**Bulker Q&As and CIs on the IACS CSR Knowledge Centre**

KC#192

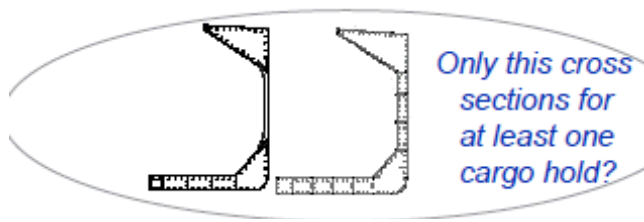
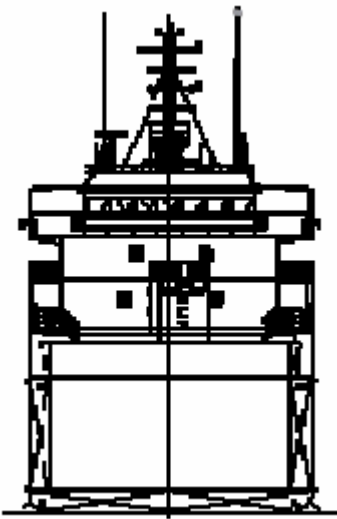
191	1/1.1.1.2	Question	application of CSR	2006/10/2	Are the following ships not subject to CSR due to their cross section design? - ore carrier - combination carrier - cement carrier - wood chip carrier - open hatch carrier	No, such ships are not subject to the CSR for bulk carriers.	
192 attc	1/1.1.1.5	Question	hull materials	2006/10/2	Ships whose hull materials are different than those given in [1.1.4] and ships with novel features or unusual hull design are to be individually considered by the society, on the basis of the principles and criteria adopted in the present Rules. (1) Is the word "ships" the bulk carriers as defined in [1.1.2]? (see drawing 1 in <a href="#">attachment</a> ) (2) Can "Novel features" and "unusual hull shapes" be used to include vessels as shown? See drawing 2 in <a href="#">attachment</a> - Can this design be included in the term novel feature?	(1) Yes, the ships with cross sections indicated in figure are defined as bulk carriers. (2) The treatment of "Novel features" and "unusual hull shapes" depends on the discretion of each Classification Society.	<a href="#">Y</a>

KC#279

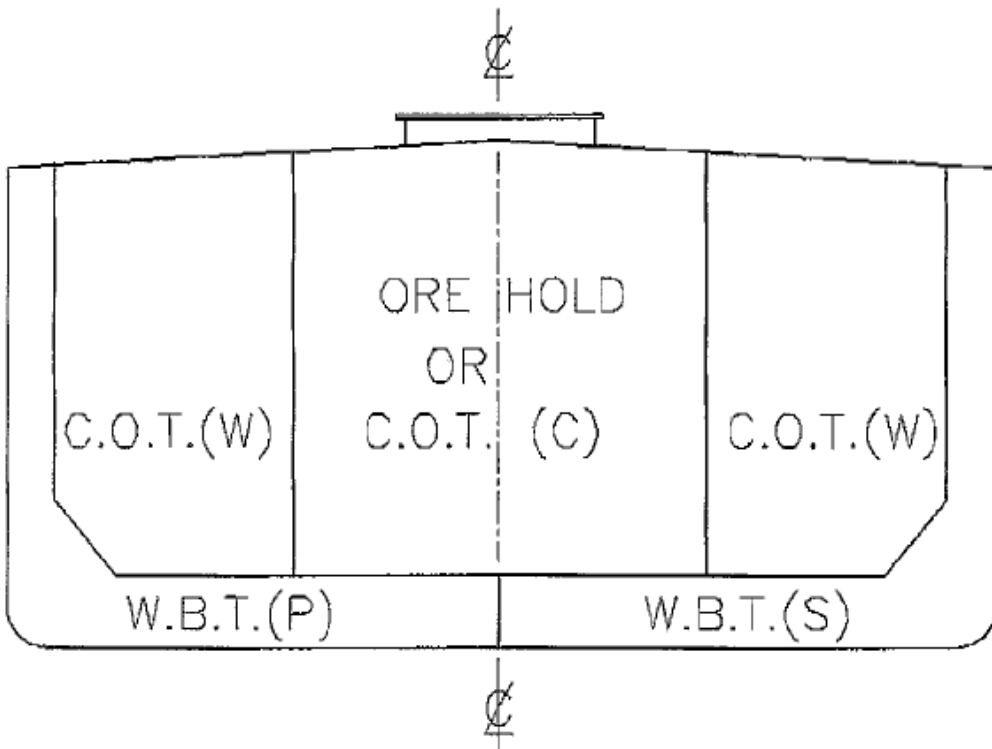
193	1/4.3.3.3	Question	length	2006/10/2	The midship part of a ship is the part extending 0.4L amidship, unless otherwise specified." Could you elaborate on what this means?	The midship part is the extent of 0.3L to 0.7L from the aft end (A.E.) of the rule length L.	
279 attc	1/1.1.1	Question	application	2006/11/13	Is CSR applicable for VLOO (Very Large Oil or Ore) carrier having configuration very similar to VLCC, but with hatch opening in center hold/tank? See <a href="#">attached</a> sketch.	CSR Tanker or Bulker Rules are not applicable for Ore-Oil Carriers.	<a href="#">Y</a>

KC#410

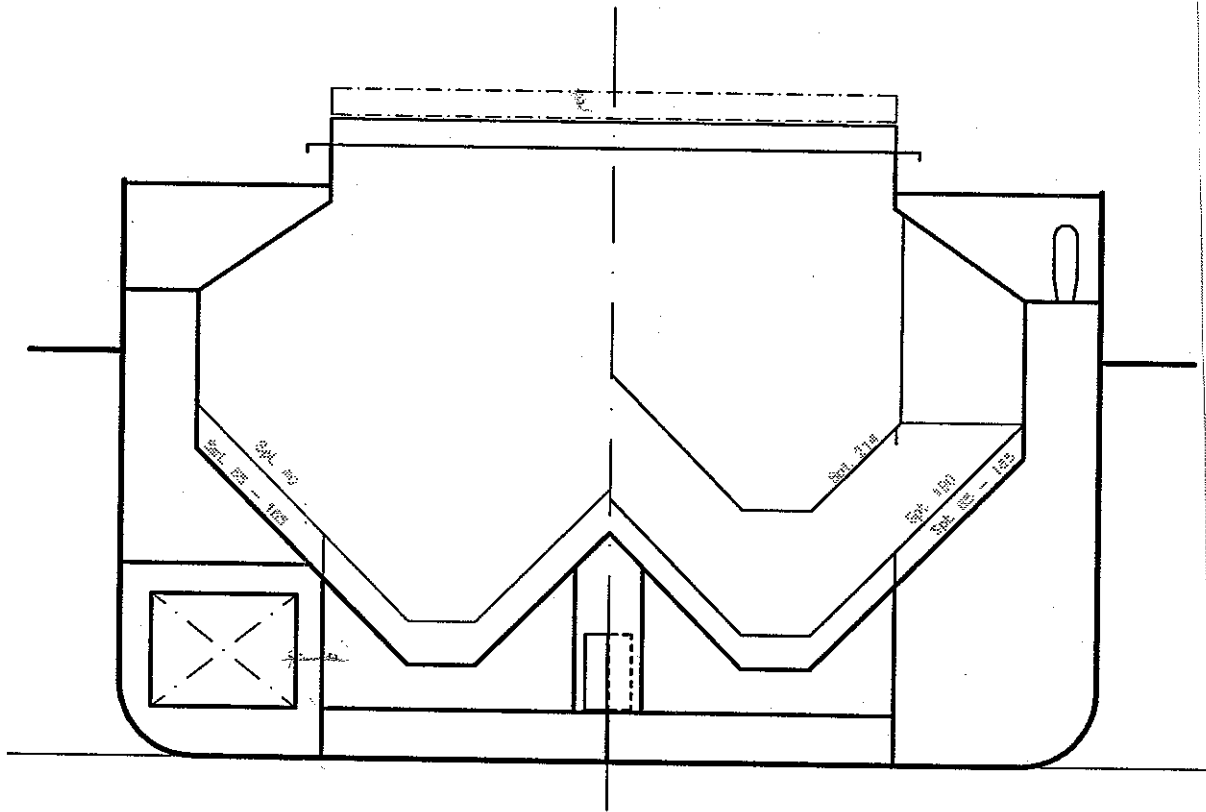
410 attc	1/1.1.2	Question	Lime Stone Ship	2007/3/15	<p>Is CSR/Bulker applied to the attached self-unloading lime stone ship ?</p>	<p>No, the CSR is not applicable to the concerned design of the self-unloading lime stone ship.</p>	<p><a href="#">Y</a></p>

1. Machinery Space

2. Belt Conveyor Space is penetrating through all bulkheads in cargo holds and continuing through Cargo Area.

KC#511

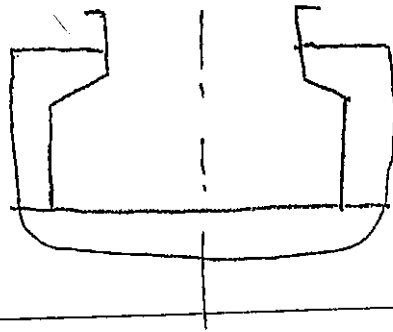
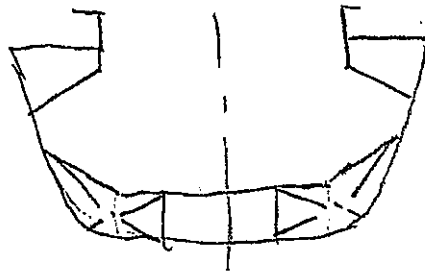
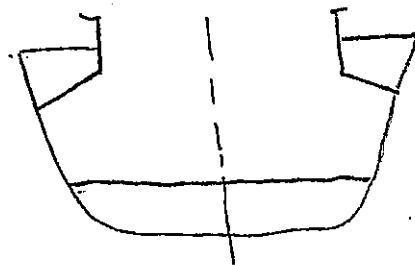
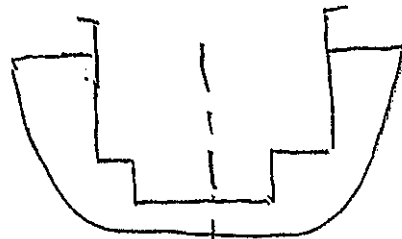
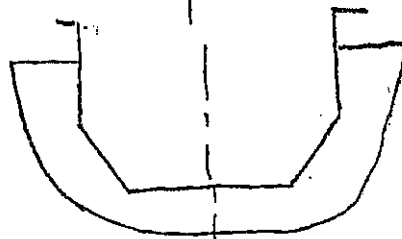
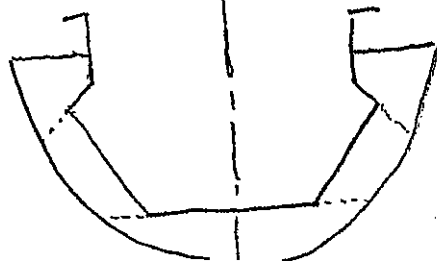
511 attc	1/1.1.1.2	Question	Midship section & Sections in cargo holds	2007/9/25	The midship section and sections in cargo holds other than NO.1(Foremost) cargo holds are as per No.1) Midship in the <b>attached</b> sketches. There are 5 kinds of designs of NO.1 cargo hold as shown in No.2) through No.6) in the attached sketches. Please advise whether the respective designs No.2) through No.6) need to comply with the CSR requirements.	In case of designs as per the sketches No.3) thru 6) for No.1 cargo hold section CSR needs not be applied. However CSR needs to be applied for the case of sketches No.2.	<a href="#">Y</a>
514	1/4.2.1.1	CI	Definition of Ship's speed V	2007/8/28	Ship's speed, V, is defined in Ch1 Sec4, 2.1.1 as Maximum ahead service speed, in knots. My understanding is that the definition of V in CSR is same as the one in 2.1.1 of UR S10, namely maximum service speed (knots) with the ship on summer load waterline. Is my understanding correct?	Yes, your understanding is correct. <b><u>Also Included in Corrigenda 5</u></b>

KC#586

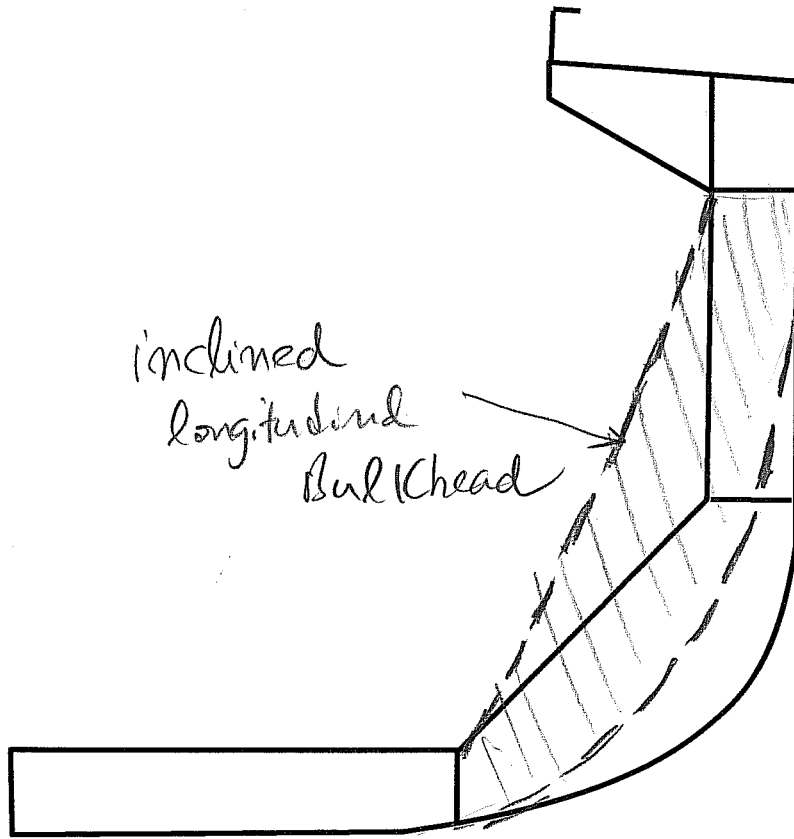
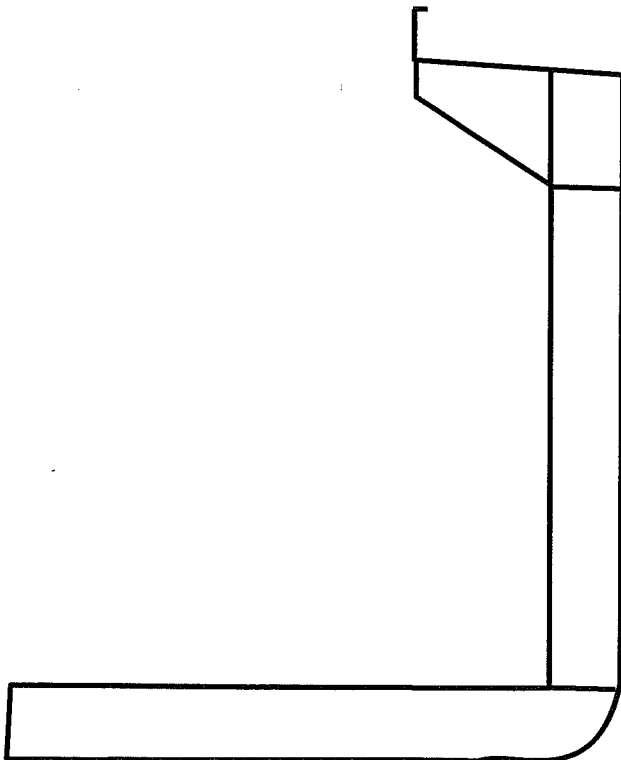
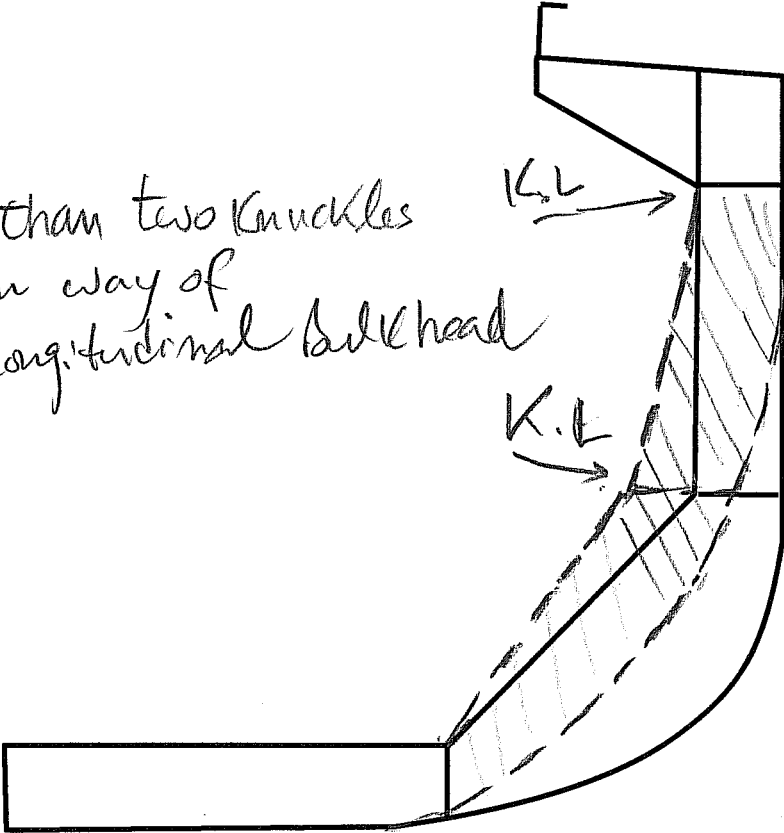
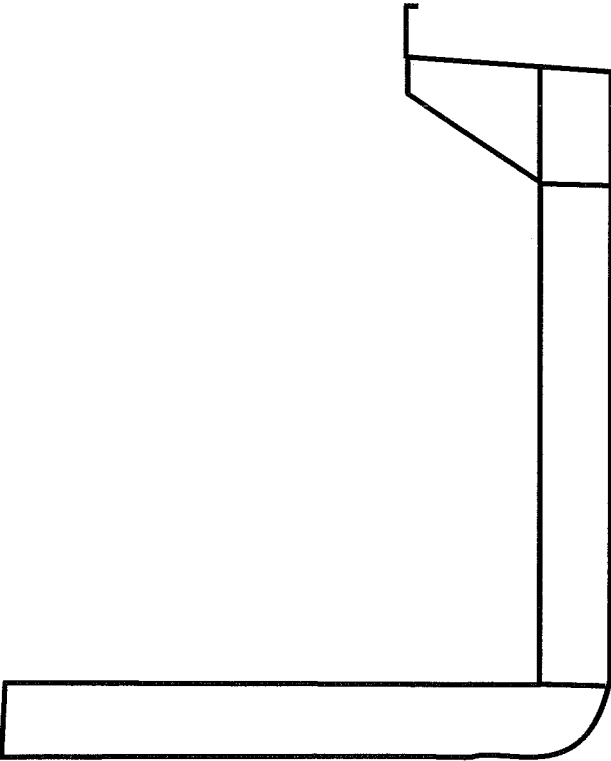
586 attc	1/1.1.1.2	CI	Longitudinal Bulkhead	2008/4/24	<p>In case we have an inclined longitudinal bulkhead, is it possible to consider there is no hopper tank and therefore not to apply CSR Rules?</p> <p>If this inclined longitudinal bulkhead is made with small change with two slopes, is it possible to consider there is no hopper tank?</p>	A few similar questions have already raised to IACS KC. IACS works on an entire answer for the application of the CSR-BC for different ship designs, considering a clear definition of the hopper tank.	<a href="#">Y</a>
587 attc	1/1.1.1.2	CI	Structure of bulk carrier in midship, aft and fore body hold	2007/10/24	<p>Please see <a href="#">attachment</a> for structure of bulk carrier in midship hold and aft and fore body hold.</p> <p>In this case, whether or not is CSR mandatory?</p>	A few similar questions have already raised to IACS KC. IACS works on an entire answer for the application of the CSR-BC for different ship designs, considering a clear definition of the hopper tank.	<a href="#">Y</a>

• More than two Knuckles  
in way of  
Longitudinal bulkhead
